City of Commerce City 2012 International Residential Code

Code Amendments

(pp)The following diagram, Diagram P2717.4, is added to be used in conjunction with Sections P2717.2 and P2717.3:

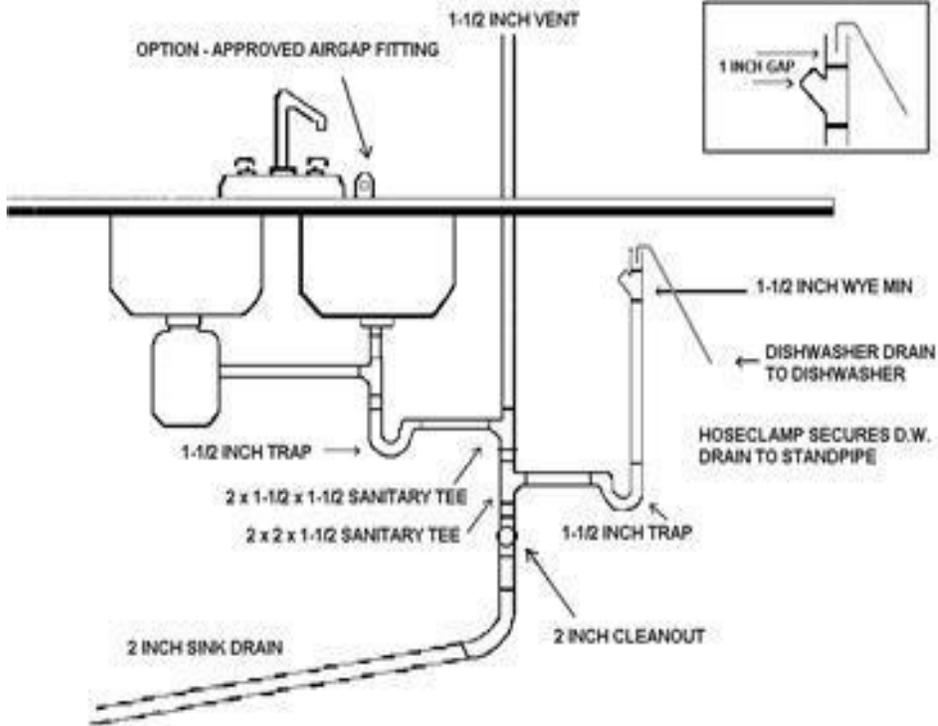
A sink and dishwasher are permitted to discharge through a single 1 1/2 inch (38 mm) trap. The discharge pipe from the dishwasher shall be increased to a minimum of 3/4 inch (19 mm) in diameter and shall be connected with a wye fitting to the sink tailpiece. No domestic dishwashing machine shall be directly connected to a drainage system or food waste grinder without the use of an approved dishwasher air gap fitting on the discharge side of the dishwashing machine. Listed air gaps shall be installed with the flood level (FL) marking at or above the flood level of the sink or drain-board, whichever is higher or separately trapped with the air gap located on the stand pipe in accordance with Diagram P2717.4.

The combined discharge from a sink, dishwasher, and waste grinder is permitted to discharge through a single 1 1/2 inch (38 mm) trap. The discharge pipe from the dishwasher shall be increased to a minimum of 3/4 inch (19 mm) in diameter and shall be connected with a wye fitting between the discharge of the food-waste grinder and the trap inlet or to the head of the food grinder. No domestic dishwashing machine shall be directly connected to a drainage system or food waste grinder without the use of an approved dishwasher air gap fitting on the discharge side of the dishwashing machine. Listed air gaps shall be installed with the flood level (FL) marking at or above the flood level of the sink or drain-board, whichever is higher or separately trapped with the air gap located on the stand pipe in accordance with Diagram P2717.4.
